Register Reference: SD23A/0001ai **Date:** 26-Jan-2023
Development: Construction of a 7 storey hotel building over 2 basement levels comprising of 254 bedrooms and 8 penthouse suites, reception, exercise room, bar and restaurant, staff facilities, outdoor plaza area, business / conference rooms, 148 car parking spaces and 36 bicycle parking spaces; Works to existing vehicular access at the north of the site and all associated site enabling and excavation works, ESB substation, plant, storage, hard and soft landscaping, green roofs and signage.
Location: Site D, Liffey Valley Office Campus, Dublin 22
Applicant: Winmar Developments Unlimited Company
App. Type: Permission
Planning Officer: SARAH WATSON
Date Recd: 05-Jan-2023
Decision Due Date: 01-Mar-2023

Roads Department Assessment:

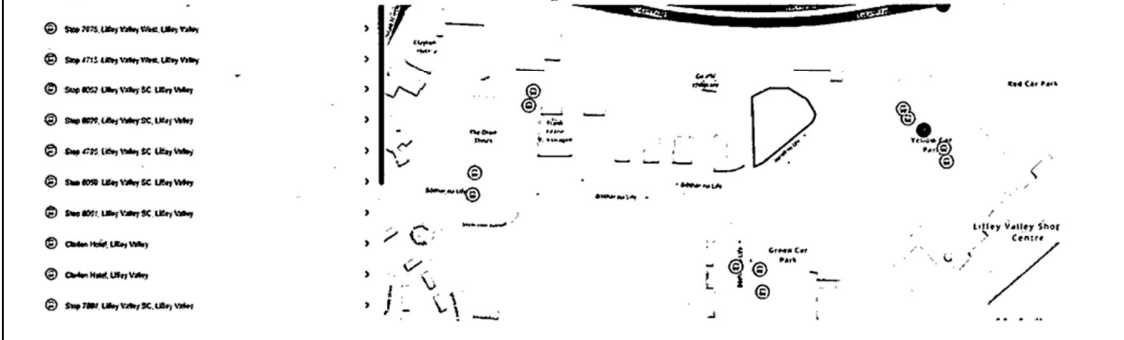
Confirmation from Transport Infrastructure Ireland (TII) that the bus stop/layby opposite to the vehicle access is no longer required and will be removed.

The applicant has surmised that the lay-by opposite their proposed entrance will not be used in the future. However, while the lay-by remains there is a possibility that it can be used for bus set down, parking etc. This would be opposite the applicants proposed entrance and may lead to unwanted or additional traffic movements at this location. The applicant is requested to relocate the access point or investigate the removal of the lay-by.

In response to Item 3(ii), the Design Team have reviewed the lay-bys to the north of the proposed building. These lay-bys are not used and were never used as a bus-stop. For many years buses did not enter into the Liffey Valley campus, despite the wishes of the owners/operators of the centre. Instead, the bus stops were located together at the edge of the campus. It was only recently (19th February 2023) that the new €20million Liffey Valley

Bus Plaza was opened as part of Bus Connects. It is very close to the site and therefore additional bus stops are not likely to be needed or developed just outside the entrance to the plaza. Such a location would be unrealistic. In the unlikely event of TII requiring the use of these laybys they have the option of making a submission to the Planning Authority, but have not done so. See image overleaf showing relationship of bus plaza to the application site, outlined in red. Note also the location of bus stops. Source: TII website.
